BURLINGTON DEVELOPMENT REVIEW BOARD

To: Development Review Board
From: Mary O'Neil, AICP,
Principal Planner
Date: August 2, 2016
RE: ZP16-1506CA/CU 0
University Road / 290 East
Avenue

Request: Construction of a new 1 story building for UVM Rescue Services. Sidewalk and parking reconfiguration, no change in the overall number of parking spaces.

Drawing No.
ES-1

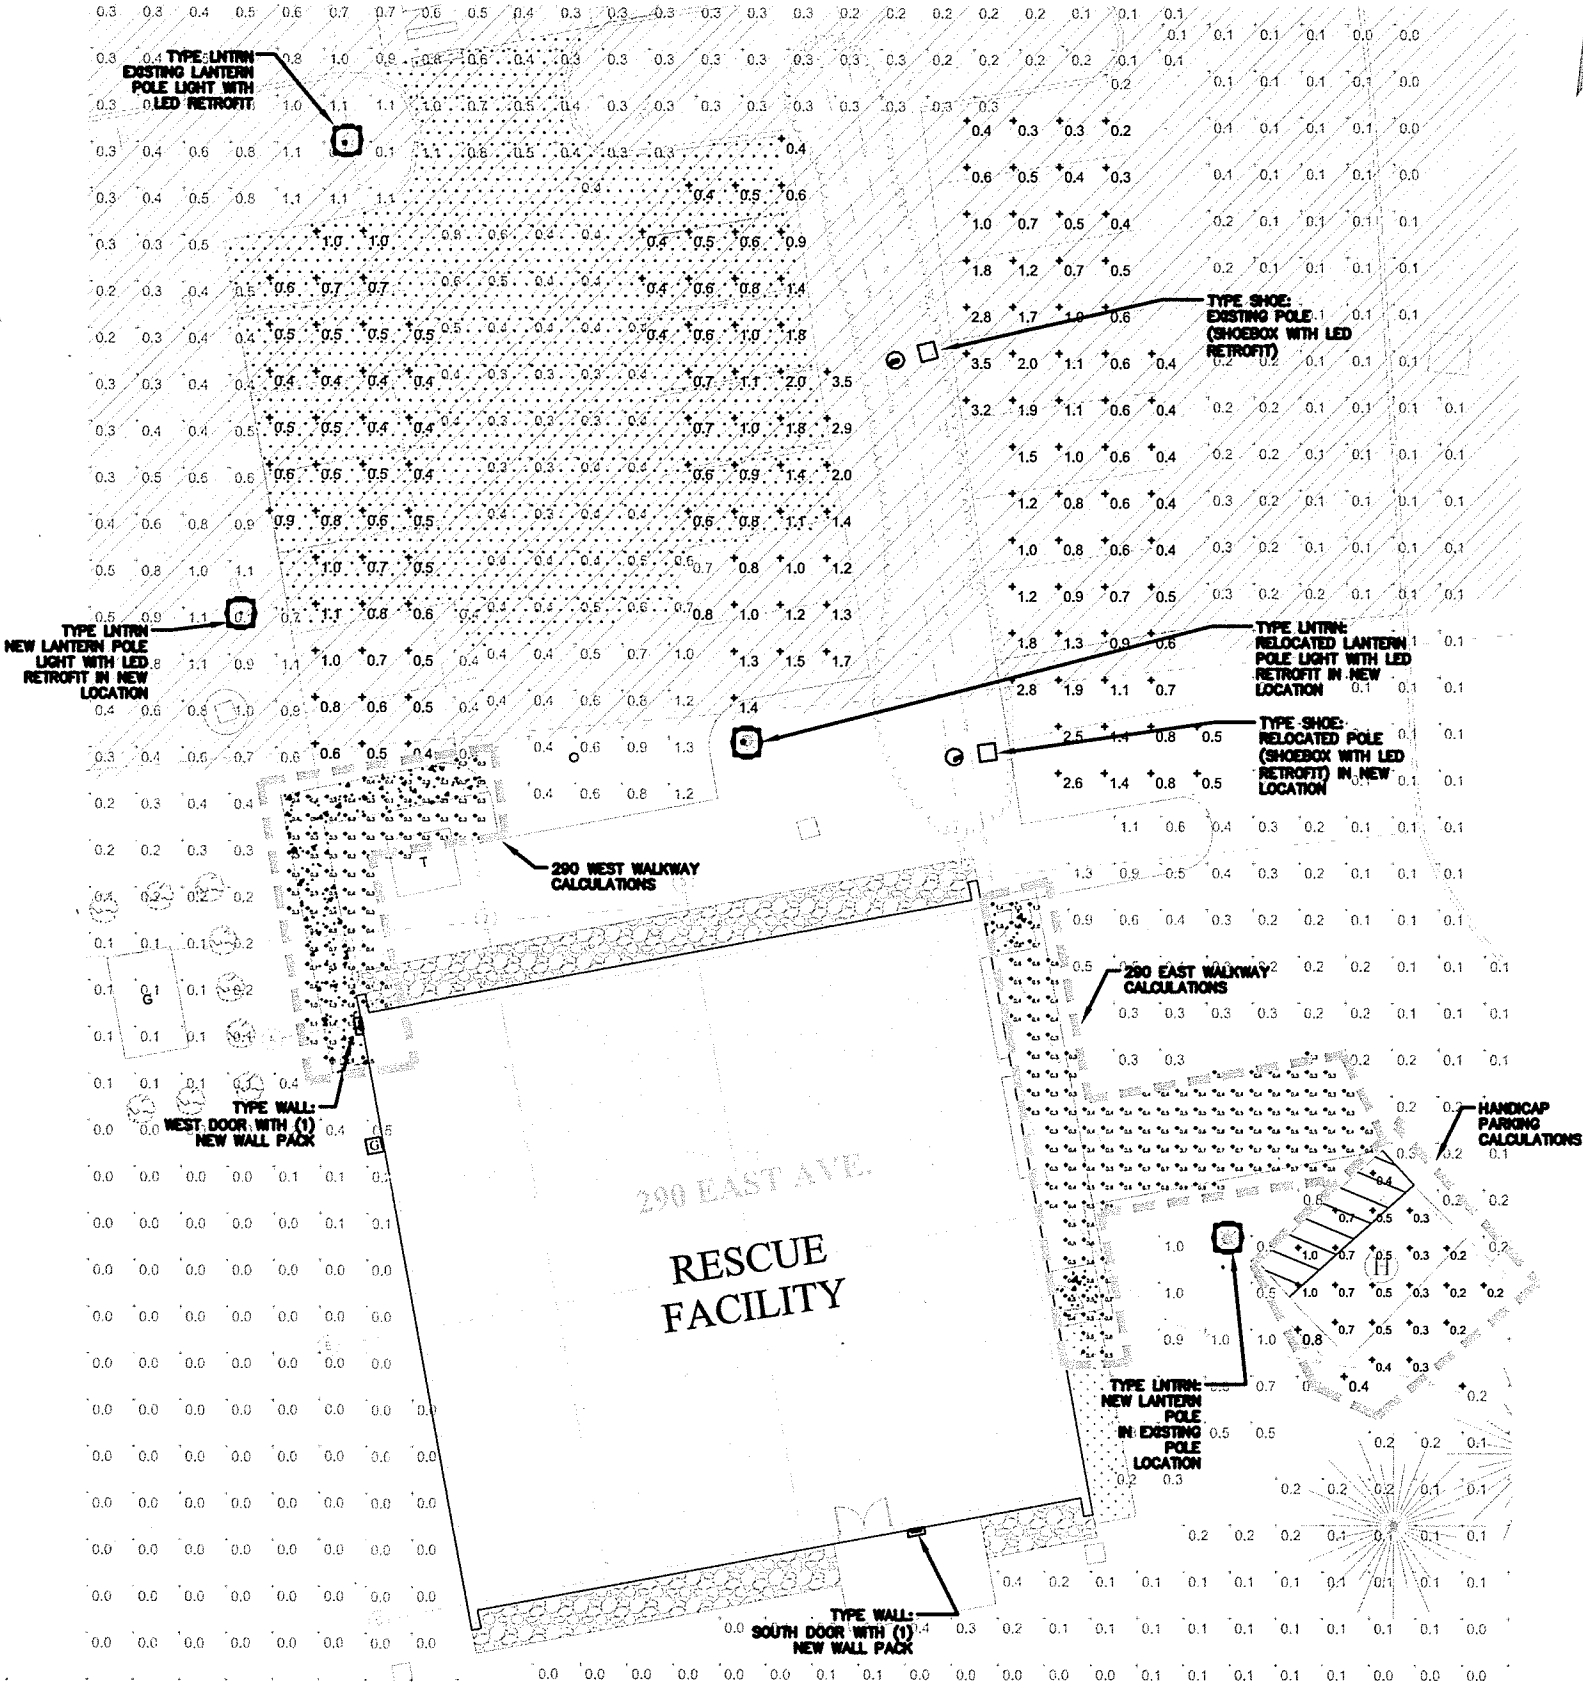
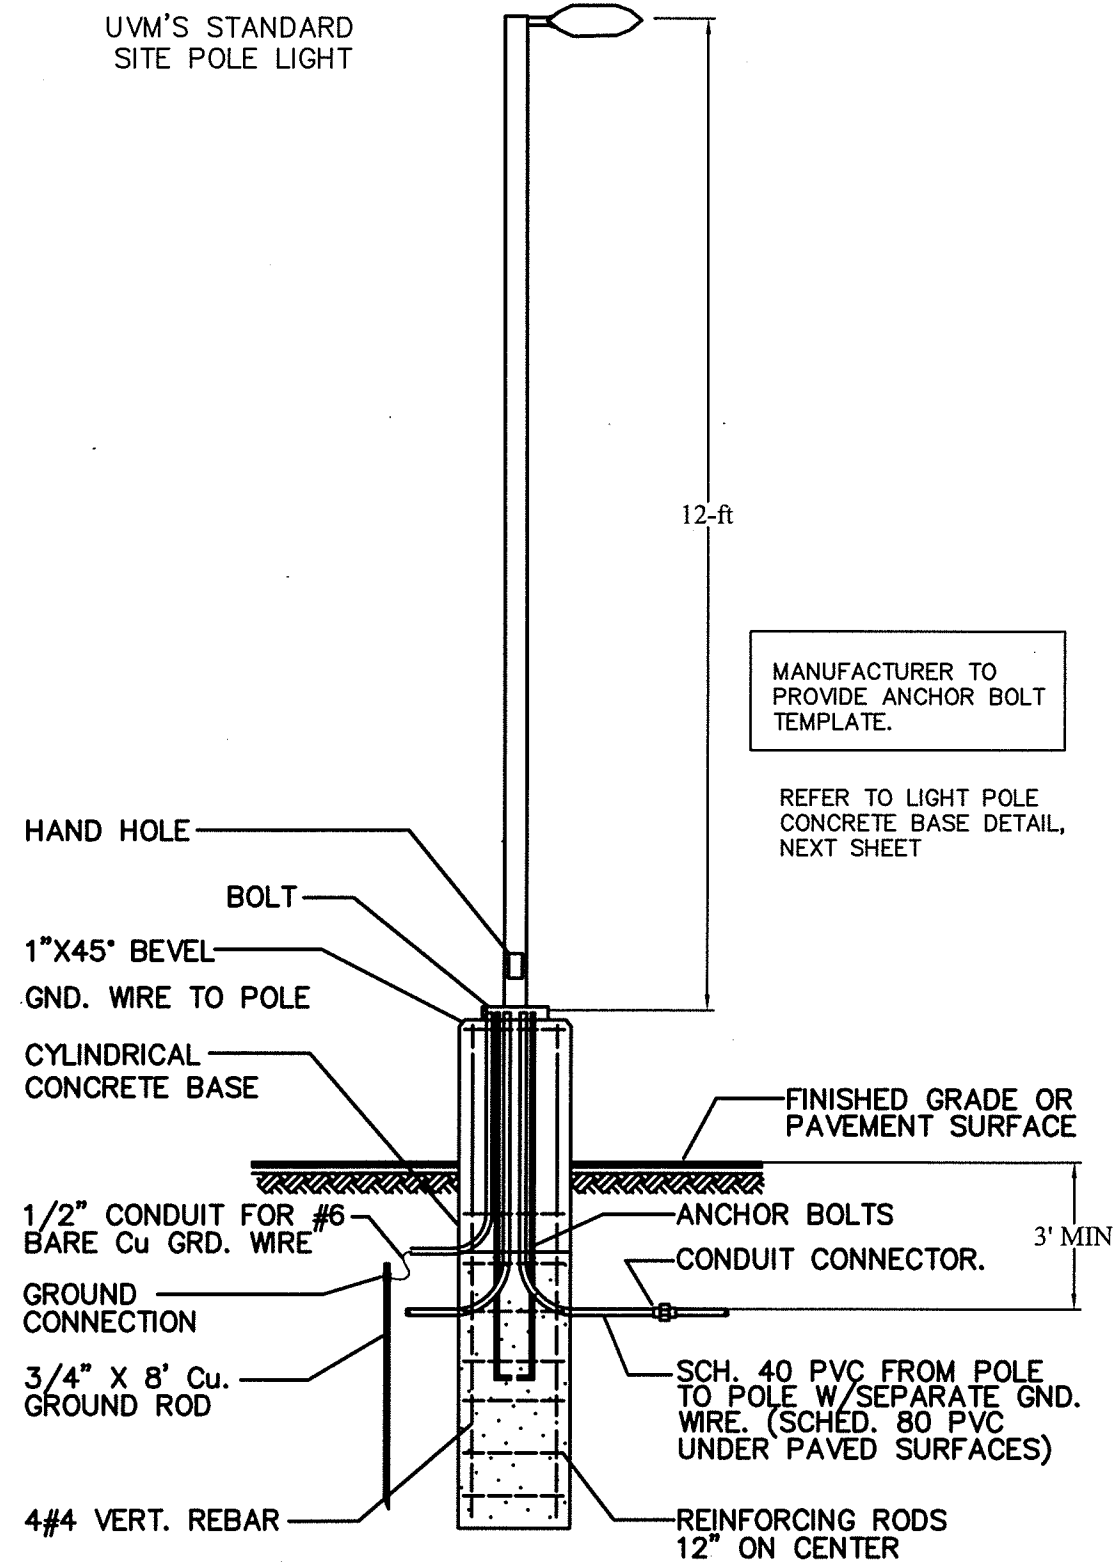
The project includes exterior mounted LED wall luminaires, two new lantern poles and two relocated lantern poles with retrofitted shoebox LED fixtures. Light levels meet the requirements of Section 5.5.2 (f) 1. (Parking lot lighting) and 2. (Walkway lighting.) See Plan ES-1.
